Service Bulletin
Y	For Factory Service Release Only	Product: ScanIR II	Service Bulletin No.: SB-S2-001
Y	For Field Service Release Only	Issue Date: 27 Feb 2004	Page 1 of 3
Y	For External Release

- A. Products: ScanIR II Power Supply / Processor Boxes
- B. Models: All
- C. Serial Numbers: All

Exhibit #2

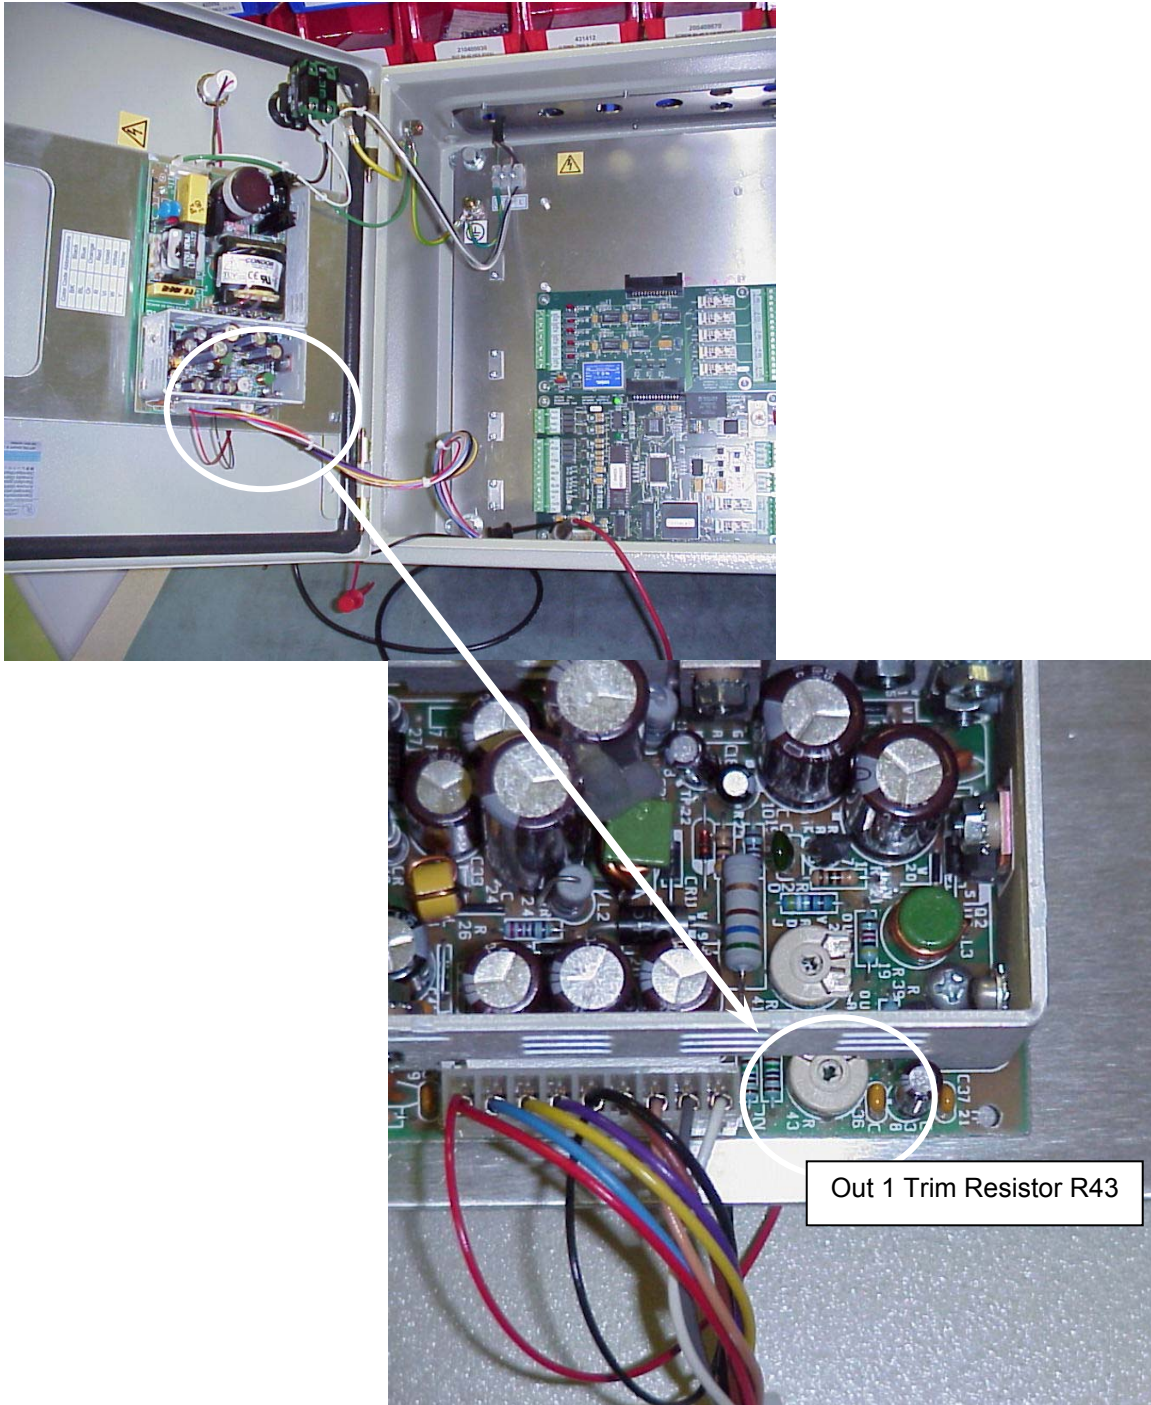
- A. With ScanIR II already powered-up and running, measure the voltage between JP100 pin 3 and TP 100. See Exhibit #1.
- B.
- C. If the reading is less than 5.15 volts, adjust the Out 1 Trim resistor R43 on the switching power supply by turning clockwise until the measurement indicates 5.15 volts. See Exhibit #2.

The combination of low power supply voltage levels and spikes of up to 200 millivolts from digital logic can cause the voltage to dip below the threshold of the automatic system reset circuit. Readjusting the power supply to 5.15 volts will make the ScanIR II system more tolerant of these environmental conditions and ought to eliminate false communication and reset problems.
